**MarkWest Houston Gas Plant  
Inspection Report  
Chartiers, Pennsylvania**

Region III Office of Air Enforcement & Compliance Assistance  
Inspection Date: April 28-30, 2015

2. ISS Leak Tag on Flange 001703 – MarkWest Houston – 04/28/2015

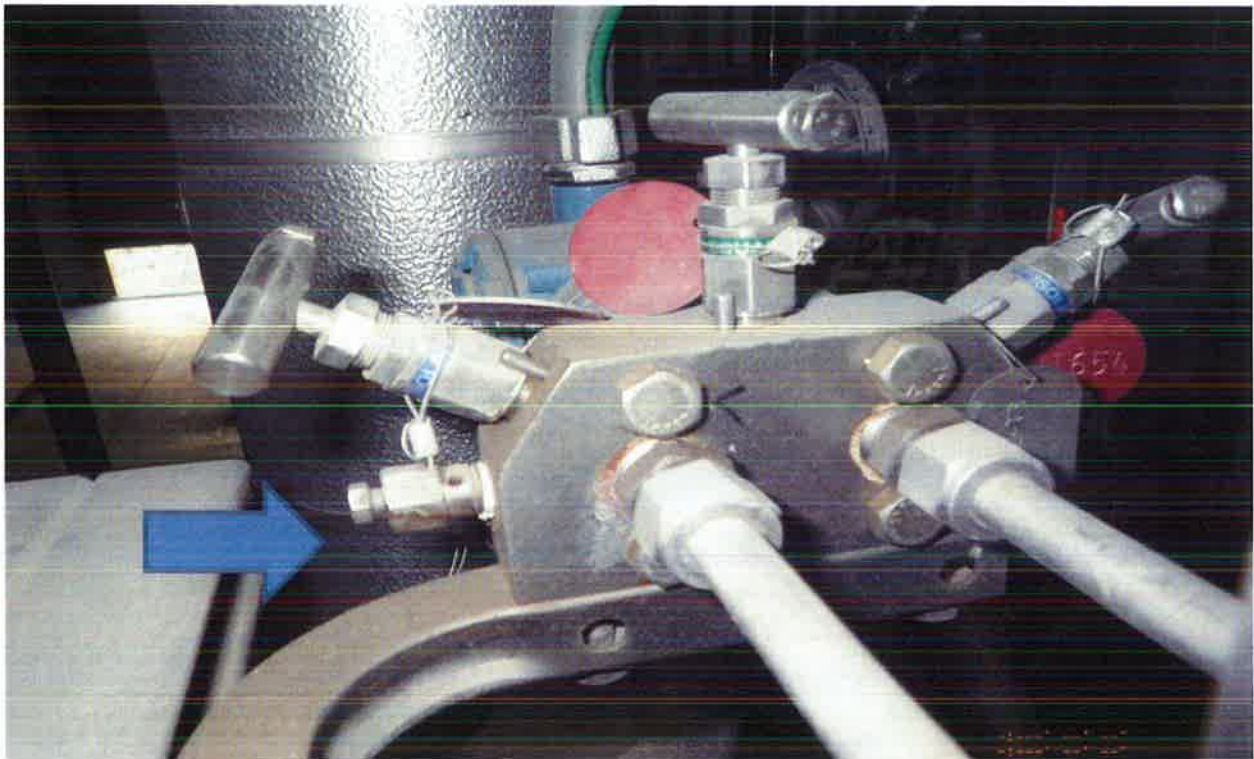
- There were six new stainless steel valves observed on the H1 inlet line near component 000195 that were not identified as part of the LDAR program.
- An LDAR leak tag was observed on component 1703.1 that was leaking on 12/12/13. No recheck date was listed on the LDAR tag (See Photo 2 on Page 1 of Inspection Photos).
- Multiple LDAR tags (24) were observed on the residue line in this area.<sup>5</sup>

4. Bleeder Valve next to 001656 not tagged for LDAR – MarkWest Houston – 04/28/2015

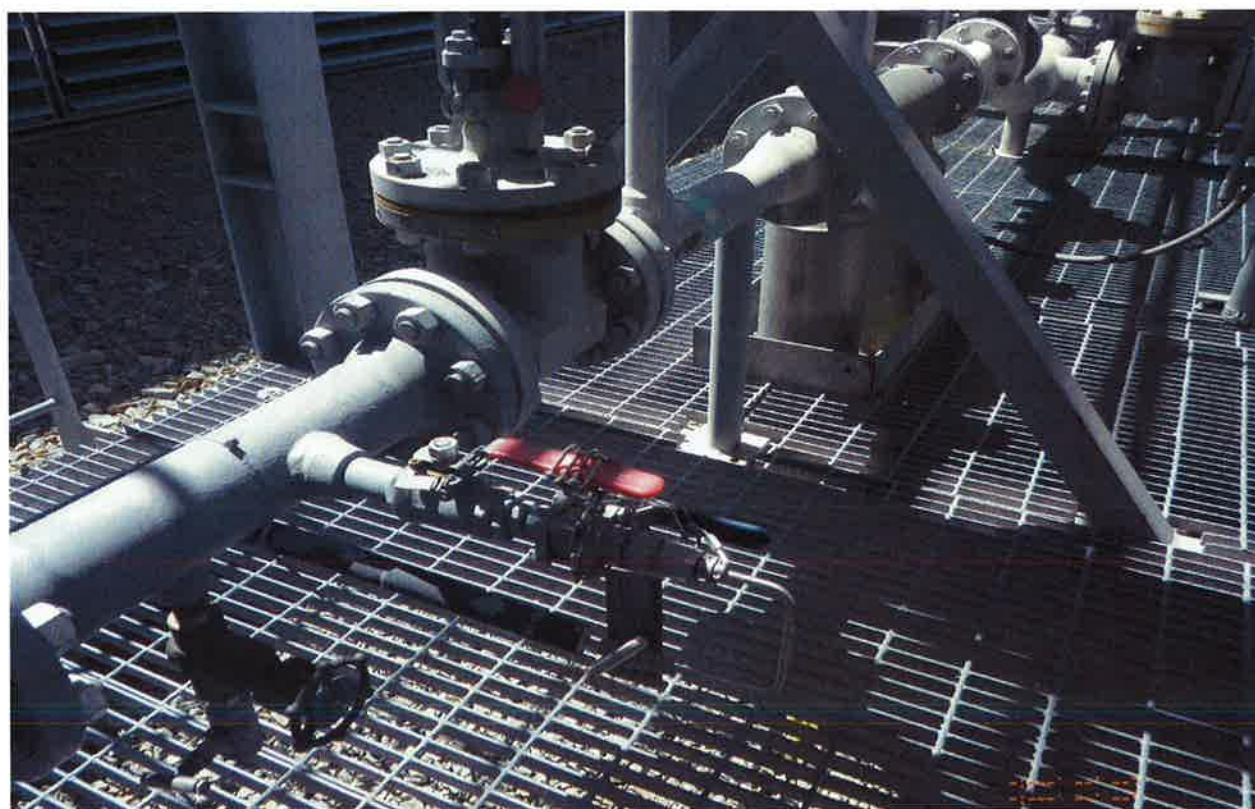
- Approximately 10-15 valves that are part of the Regen SCR around V-130 were not tagged.
- Valves to the right of Tag# 001667 were not tagged. These appear to be new components.
- All bleeder valves that are part of the instrumentation assemblies (also called vent plugs) are not tagged as part of the LDAR program (see Photo 4 on Page 2 of Inspection Photos).
- There were approximately 6 insulated valves that were observed with no access to the valve to effectively conduct Method 21 monitoring.

14. Mariner East Propane Pipeline Untagged for LDAR – MarkWest Houston – 04/29/2015

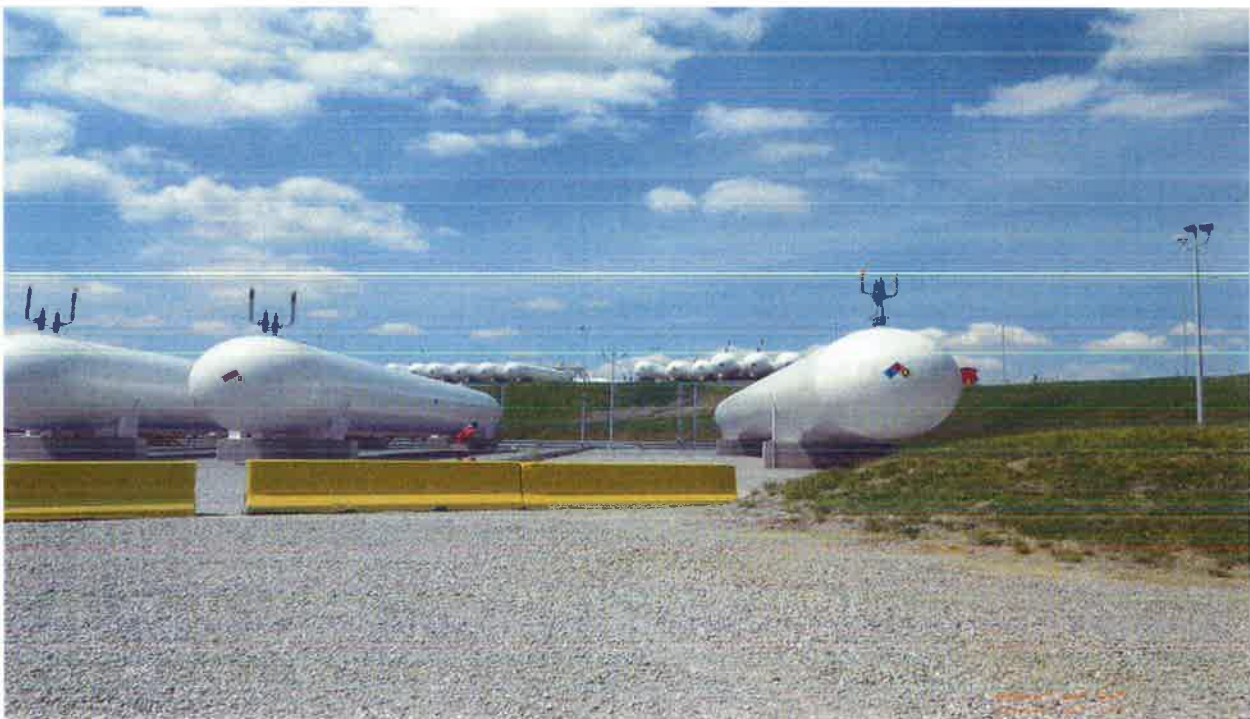
- The Mariner East Pipeline<sup>6</sup> runs adjacent to the facility and there is a tie-in on MarkWest property. There are no LDAR tags on this line.
- There are sporadic tags in the propane refrigeration building with some lines being tagged partially while the remainder of the line isn't tagged.
- EPA observed several hundred LDAR tags on lines downstream of the De-ethanizers which should not be included in the LDAR system.
- At least five valves were observed on insulated lines with no access port for LDAR monitoring.
- There were no LDAR tags on any equipment located in Storage Pad 3. There are nine bullet tanks in this area.

15. Pad 3 N-Butane Storage Bullets – MarkWest Houston – 04/29/2015

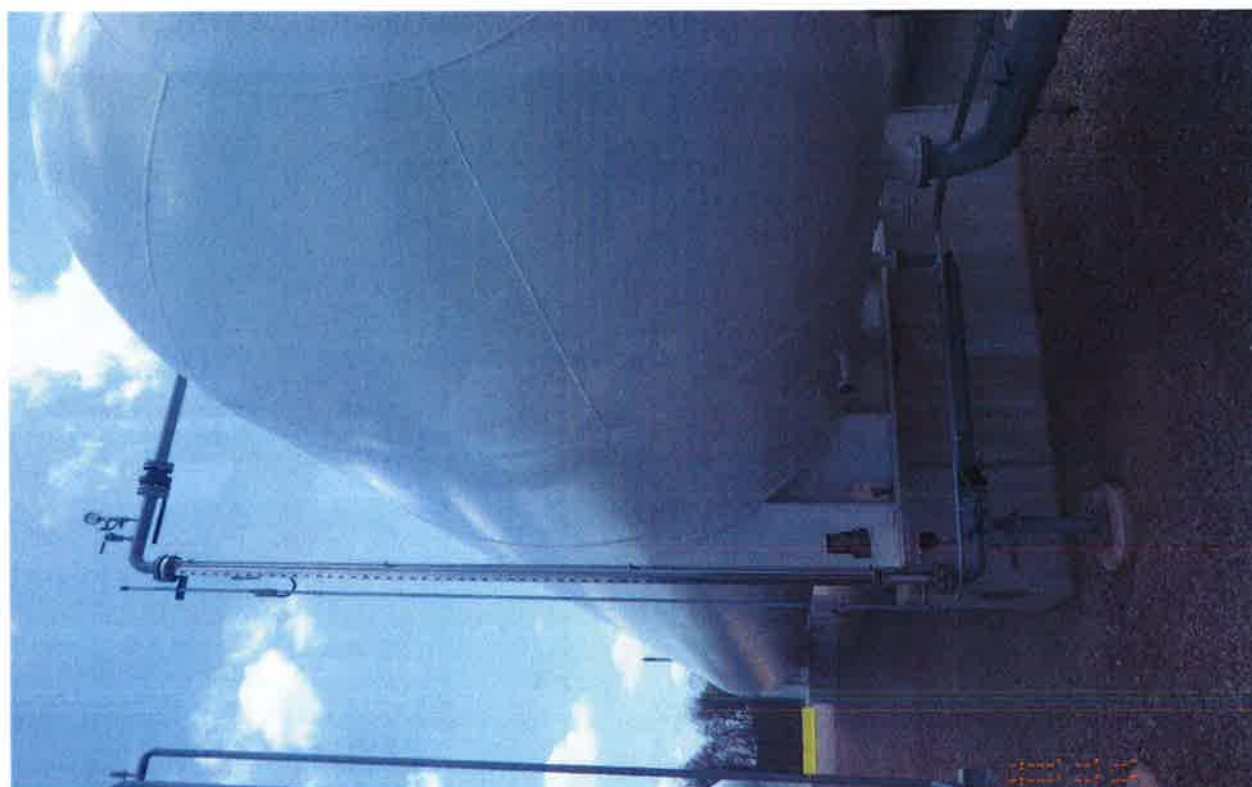
6. There were no LDAR tags and all of the components in the Storage Pad 3 (Nine n-butane storage tanks) were not included in the LDAR program. Mark West commenced identifying and tagging this area while the inspection was ongoing. After the inspection MarkWest stated that 281 valves, 660 connectors, and 18 process safety valves were tagged in this area.
